M42 Junction 6 Development Consent Order Scheme Number TR010027

8.99 Response to the ExA's Commentary on the dDCO

Response to the ExA's Commentary on the dDCO

Regulation Number	Rule 8(1)(k)
Planning Inspectorate Scheme Reference	TR010027
Document Reference	8.99
Author	M42 Junction 6 Project Team & Highways England

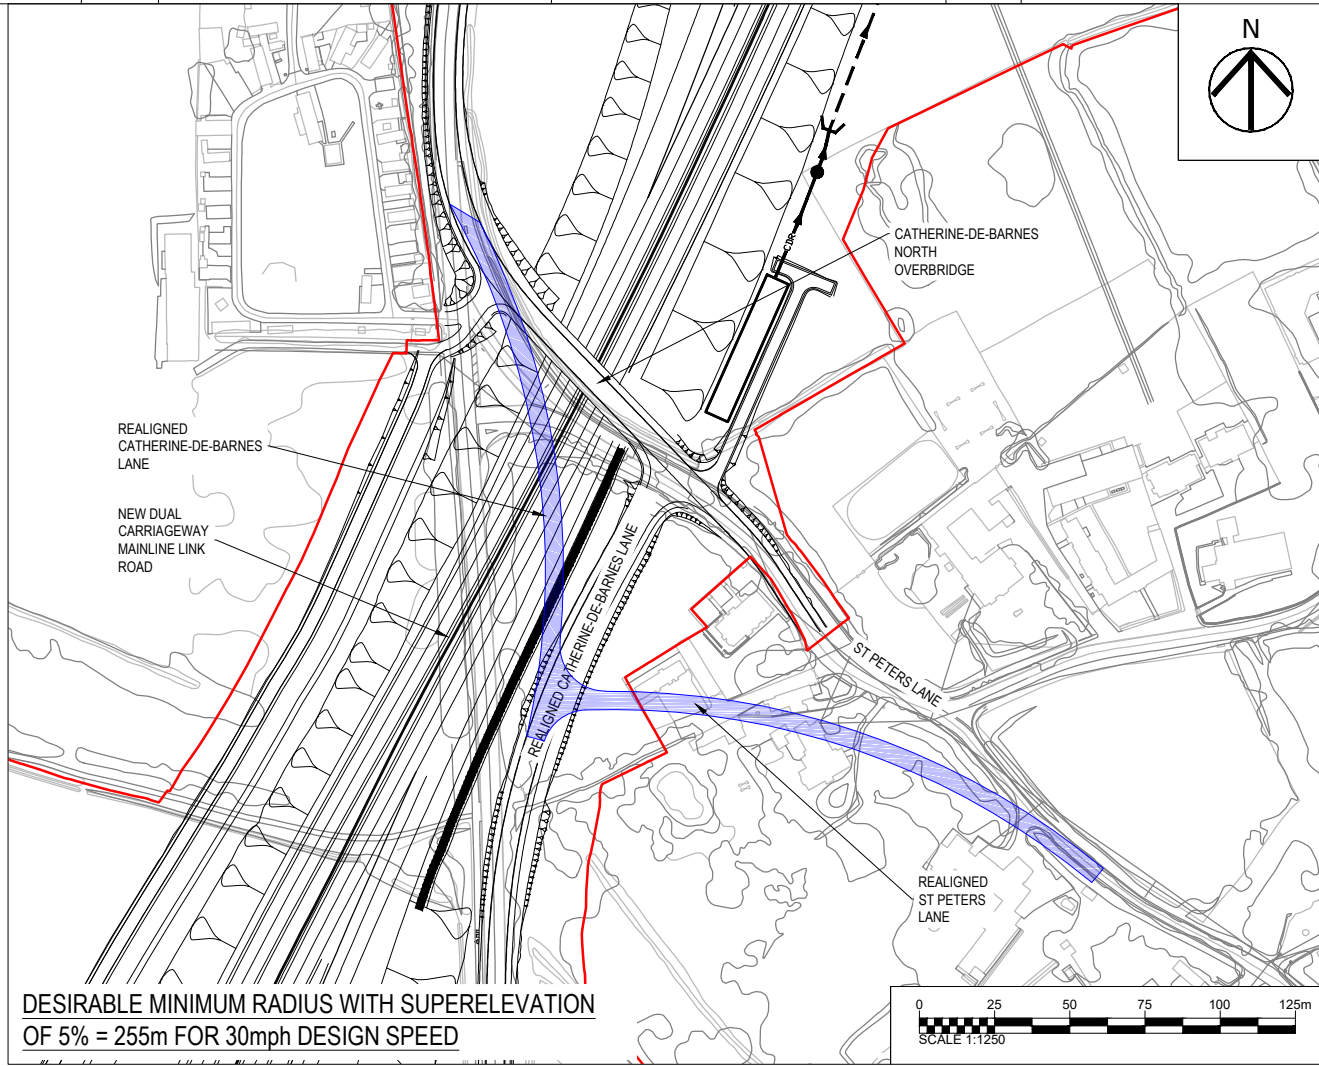
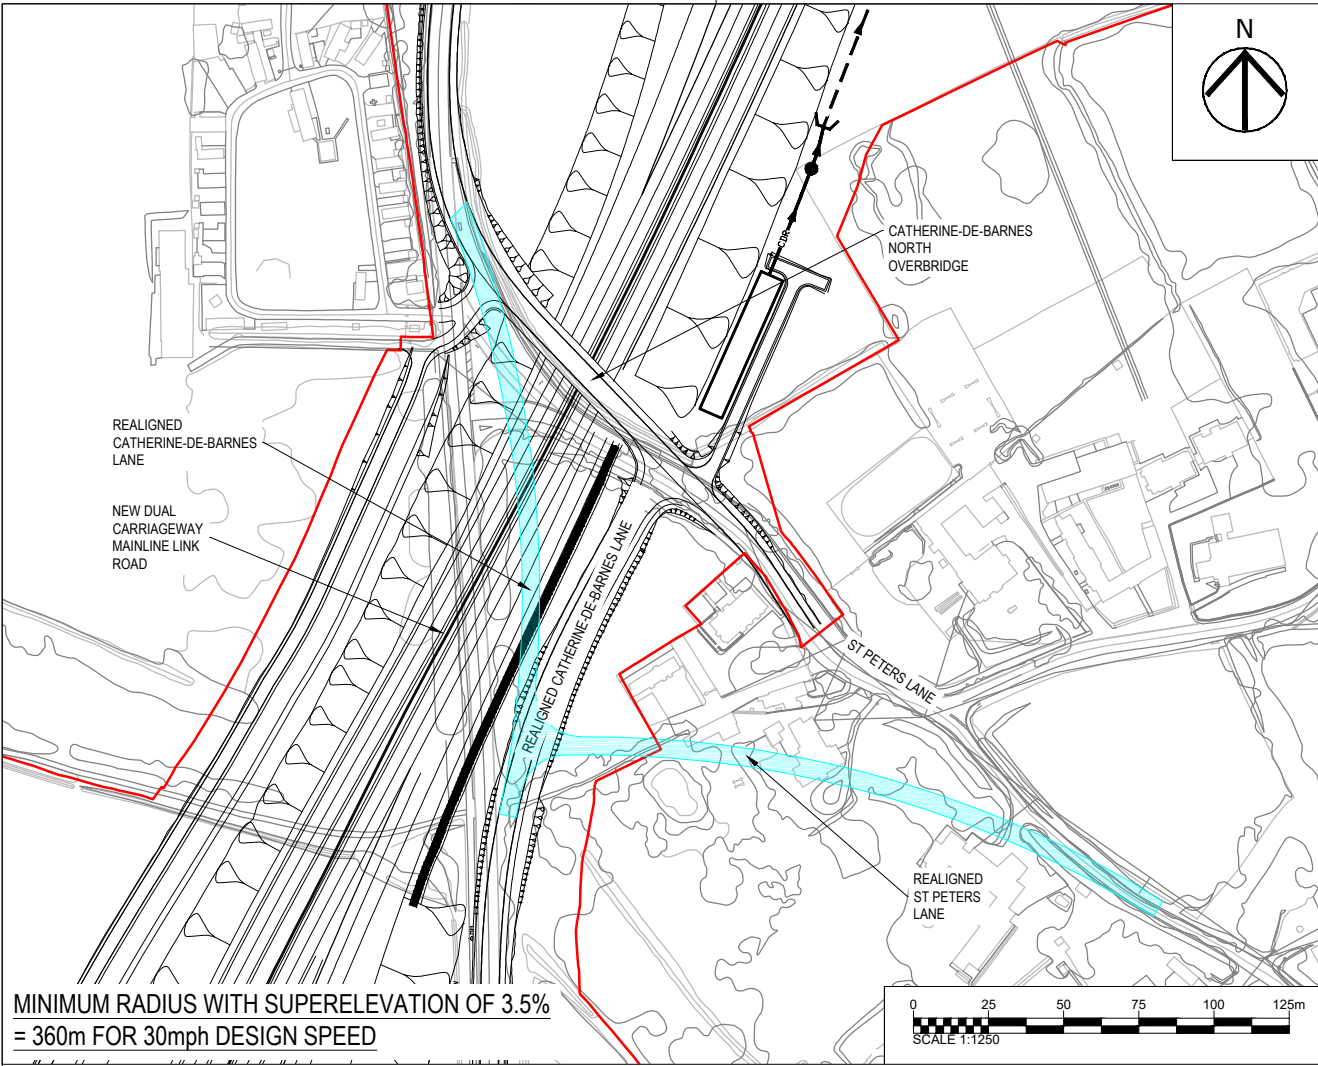
Item Number	Commentary, Response Sought and the Applicant's Response	
13	New R15 Altering the Priority of the Catherine-de-Barnes Lane and St Peters Lane Junction	<p><u>ExA's Commentary:</u></p> <p>The ExA note that the Applicant has previously considered the altered priority for this junction but discounted it due to the need for a departure from standards for the horizontal radius of the bend onto the northern overbridge, for the consequent visibility round the bend and for the visibility to the left at St Peter's Lane: and, the possibility that the 'straight' alignment might encourage vehicles leaving St Peter's Lane to do so without stopping.</p> <p>The ExA acknowledge that the road layout might need to be altered, but they do not agree that land beyond the Order limits would be required, or that necessary road signs and safety features would clutter the roadside scene (similar signs and features would be required by the current proposal) or that the departure from standards would lead to worse or unacceptable road hazards; the opposite would be the case.</p> <p><u>Response sought from:</u> The Applicant, SMBC, Bickenhill and Marston Green Parish Council, Heath Cotterill, Camila Burton and David Cuthbert</p> <p>Hence, the ExA propose the insertion of a new R15 as follows:</p> <p>15(1) Notwithstanding the details shown on any Certified Plan listed in Schedule 11 of this Order, no part of the realignment of Catherine-de-Barnes Lane is to commence until a scheme for the northern junction of St Peter's Lane and Catherine-de-Barnes Lane has been submitted to and approved in writing by the Secretary of State, following consultation with the relevant planning authority on matters related to its function.</p> <p>(2) Unless otherwise agreed by the relevant planning authority, the scheme must change the vehicular junction priority from St Peter's Lane to the realigned section of Catherine-de-Barnes Lane.</p> <p><u>The Applicant Response:</u></p> <p>In designing the junction priority within the DCO scheme, the Applicant discussed potential junction arrangements, akin to the submission in [REP7-019] with SMBC as local highway authority. Following this discussion, SMBC concluded that the junction arrangement and priority within the DCO scheme was preferable.</p> <p>Derek Lawlor from SMBC confirmed at the Issue Specific Hearing on the dDCO on 23 October 2019 that the change in junction priority would not be acceptable to the local highway authority. This was because the layout would require departures from standard for forward looking visibility at the intersection with St Peters Lane.</p>

Item Number	Commentary, Response Sought and the Applicant's Response
	<p>Given the local highway authority's concerns, the Applicant has reviewed whether it is possible to provide layouts for the junction, that change the priority as requested by the ExA and comply with the recognised DMRB standards. The Applicant has produced a number of alternative layouts that meet these standards in Appendix 1.</p> <p>Within the time available to respond to the ExA's commentary, the Applicant has not been able to produce a layout that complies with DMRB standards and fits within the Order limits.</p> <p>DMRB guidelines specify the minimum acceptable radii for road alignments for a 30mph road. The options presented in Appendix 1 comply with these guidelines and take into consideration a number of other constraints, including:</p> <ul style="list-style-type: none"> the vertical and horizontal geometry of the new Mainline Link Road which is fixed by other constraints in the area; the Order limits for this DCO application; the new Bickenhill Roundabout, the layout of this roundabout is fixed by the connection with St Peters Lane and the new Mainline Link Road; and connection with the existing Clock Lane, south-west of Clock Interchange roundabout. <p>The options presented in Appendix 1 demonstrate that a DMRB compliant junction with priority for Catherine-de-Barnes Lane traffic would require land outside the Order limits. In addition, it would be necessary to demolish properties adjacent to St Peters Lane, due to the realignment of St Peters Lane and the additional length of road infrastructure required to connect to the geometric standard compliant layout.</p> <p>While the Applicant recognises that the options presented in Appendix 1 are not exhaustive, given the time available, it considers that as it has been unable to produce a DMRB compliant layout that fits within the Order limits, the proposed new Requirement 15 would be contrary to the tests set out in the Planning Inspectorate's Advice Note 15. In particular, given the stated opposition of the relevant planning authority to the reprioritisation, the Applicant considers that paragraph (2) would be ineffective and thus not reasonable, as the planning authority's preference is for a scheme which does not change the junction priority.</p>
